**CHAPTER-2**  
**POLICY, PLANNING AND**  
**SELECTION OF TECHNOLOGY**

DELHI METRO

### Policy, Planning and Selection of Technology

**Chart 2.1**  
**Funding pattern in deviation of National Urban Transport Policy**

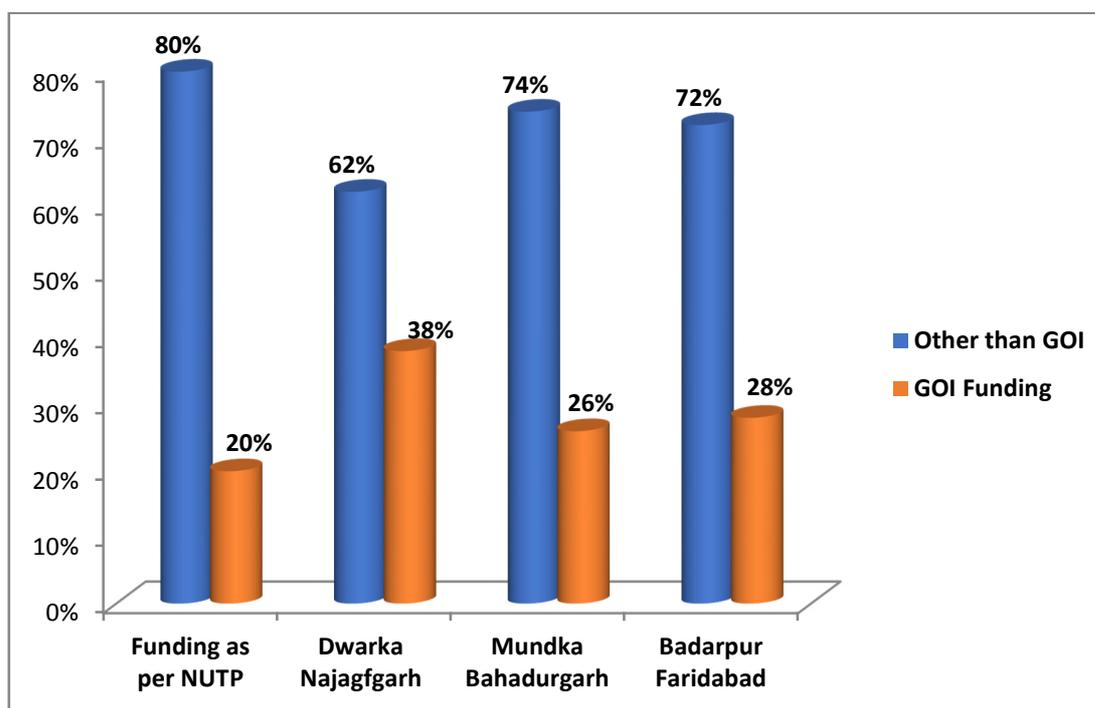
National Urban Transport Policy stipulated that in the metro rail projects being set up through the mechanism of Special Purpose Vehicle, the Central Government would offer financial support either in the form of equity or one time Viability Gap Funding (VGF) subject to a ceiling of 20 per cent of the capital cost of the project (including equity, subordinate debt and grant etc.,) excluding the cost of land and Rehabilitation and Resettlement. DMRC formulated DPRs for Phase-III corridors and extension of metro to NCR towns. The sanction orders issued by the GoI revealed that funding pattern projected in the DPRs of Dwarka-Najafgarh, Mundka-Bahadurgarh and Badarpur-Faridabad corridors were 18 per cent, 6 per cent and 8 per cent in excess over the prescribed ceiling of 20 per cent of the project cost. This resulted in excess contribution by GoI amounting to ₹165.92 crore, ₹98.82 crore and ₹156.6 crore for Dwarka-Najafgarh, Mundka-Bahadurgarh and Badarpur-Faridabad corridors, respectively.

Thus, DMRC's funding plan in the DPR was in contravention of National Urban Transport Policy, 2006.

The Ministry/ DMRC in the Exit Conference (11 January 2021) has agreed to implement the funding pattern as per National Urban Transport Policy 2006.

**Figure 2.4**  
**Views of tie plates and bolts**  
**(a) Missing bolts (b) corroded bolts & nuts**  
**(Hauz-Khas station, 18 December 2019)**

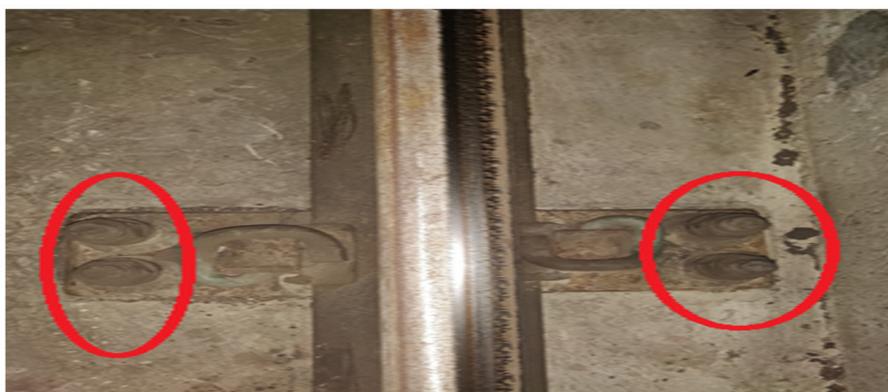
(iii) Missing bolts from the plate, besides damage on rail heads were also noticed during site visit, as shown in Figure 2.4.

The Ministry/ GNCTD/ DMRC explanation of needful action taken is not convincing because Audit noticed corrosion of rail and contaminants/ ingress from lubricated surface of head on rails during verification and there should be a process for removing the contaminant and ingress. Further, using a plate of four holes in place of two holes and leaving two holes empty may allow moisture/ water and is a source of contamination & storage.

**Functional diagram of the Communication Based Train Control system**

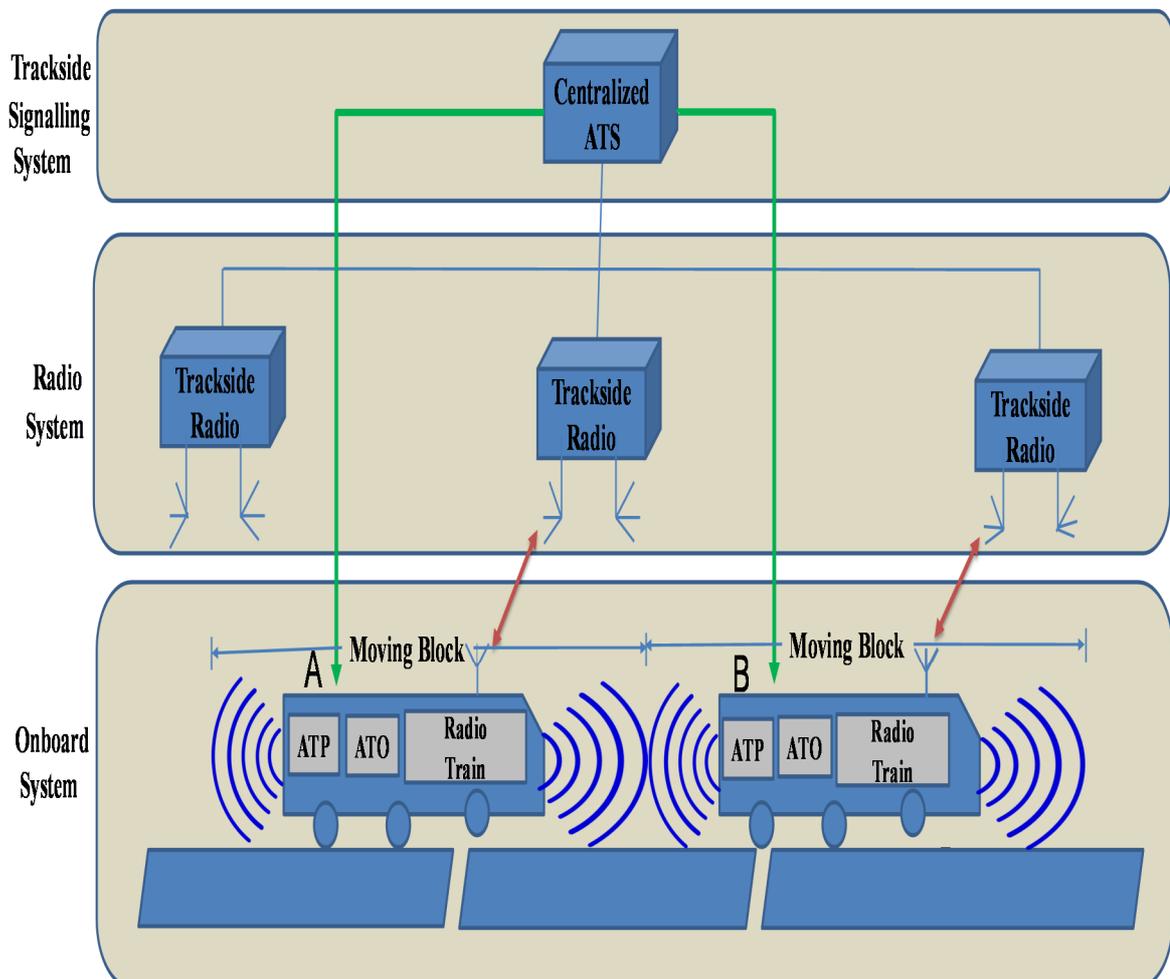
During verification at Line-8, it was observed that Access Points are wirelessly connected inside the tunnels without any redundancy. Due to curvature in the tunnels, the wireless signal from one Access Point reaches another Access Point after getting reflected through multiple paths, resulting in multipath fading (interference from several reflected paths). This may result in severely reduced amplitudes at the receiver, decreasing the reliability of the link. Due to multipath fading, this architecture has a decreased reliability<sup>54</sup>, which is a deficiency in planning or designing by DMRC. Thus, proper measurements and tests must be conducted to gain assurance regarding the possibility of fading in such architectures.

Reply of Ministry/ GNCTD/ DMRC is not acceptable as it is possible to create competitiveness amongst vendors who supply wired connections. In spite of an open tender (where both wired and wireless connectivity was allowed), a vendor with wired connectivity had qualified for Line-7, which indicate that vendors with wired connectivity are available. Thus, explicit demand for wired connectivity would have ensured the vendors to supply Communication Based Train Control system with wired connectivity. Moreover, considering the advantages that wired connectivity provides, this should be made as a requirement. DMRC further, agreed to specify certain reliability specifications that every prospective vendor must satisfy to achieve the desired performance. Technical Consultant (IIT Delhi) suggested that reliability needs be measured differently for tunnels and viaduct and to prescribe different sets of specifications for each scenario. The reliability needs should also consider the future evolution of the metro, e.g. if they plan to run the trains with headway of 90 seconds, the reliability parameter should take that into account. A proper study of the actual channel between the Access Points and the duration of its going into deep fade (when the received power is too low to receive accurately) must also be examined.
